**SUBJECT: ARKANSAS NUCLEAR ONE – NRC INSPECTION REPORT 05000313/2014005
and 05000368/2014005**

Report: 05000313/2014005; 05000368/2014005

Facility: Arkansas Nuclear One, Units 1 and 2

IR 05000313/2014005; 05000368/2014005; 10/01/2014 - 12/31/2014; Arkansas Nuclear One, Units 1 and 2, Integrated Inspection Report; Equipment Alignment, Maintenance Rule, Exercise Evaluation, Problem Identification and Resolution.

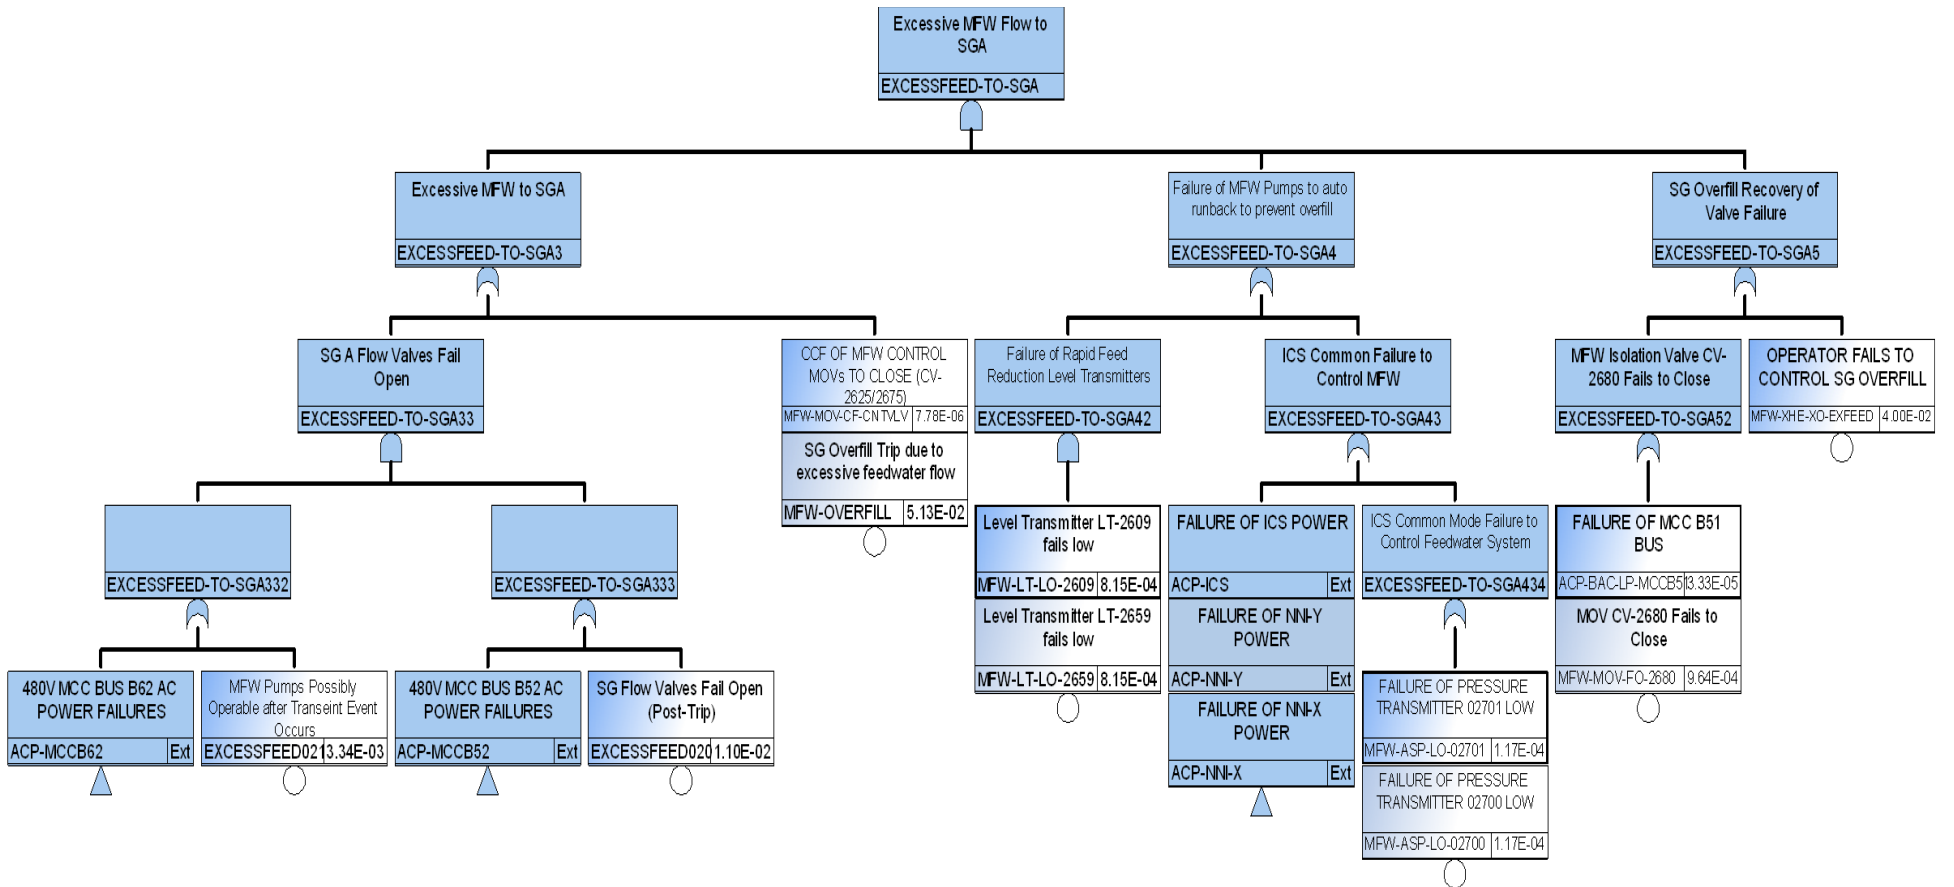
The licensee failed to provide minimum flow protection for the Unit 1 auxiliary feedwater (AFW) pump in emergency and abnormal operating procedures in accordance with the emergency operating procedure writer's guide.

Valve FW-1, the AFW pump's minimum flow isolation, is normally closed for thermal efficiency. It is a manually operated valve. All affected emergency and abnormal operating procedures direct starting the pump without opening the valve. All affected procedures also start the pump without a forward flowpath, with varying times to establish a flowpath. All times are inadequate due to the short time to pump damage.
